**SUBJECT: Checking the correct fixing
of the lifting arm stop safety device**

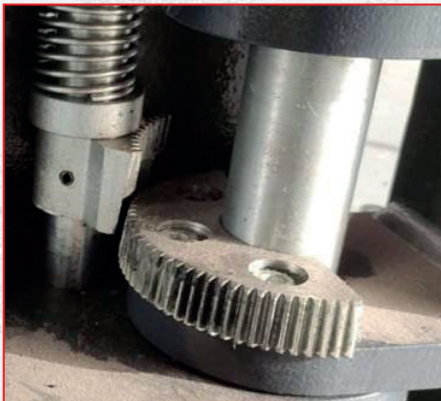
Following some checks on the safety device stopping the lifting arms for the models listed above, a case of incorrect tightening of the fixing screws in the toothed section was found. This condition affects the optimal and safe operation of the device.

Therefore, it is recommended to periodically check, at least once every 3 months, the correct functioning of the arm stop device in the lifts in question and, in particular, the tightening of the fixing screws of the toothed section.

The pictures below show the two solutions currently available.

If loose fixing screws are found, please adjust the device correctly with the arm open inwards by approximately 45° and tighten the screws with a torque wrench at 40 Nm.
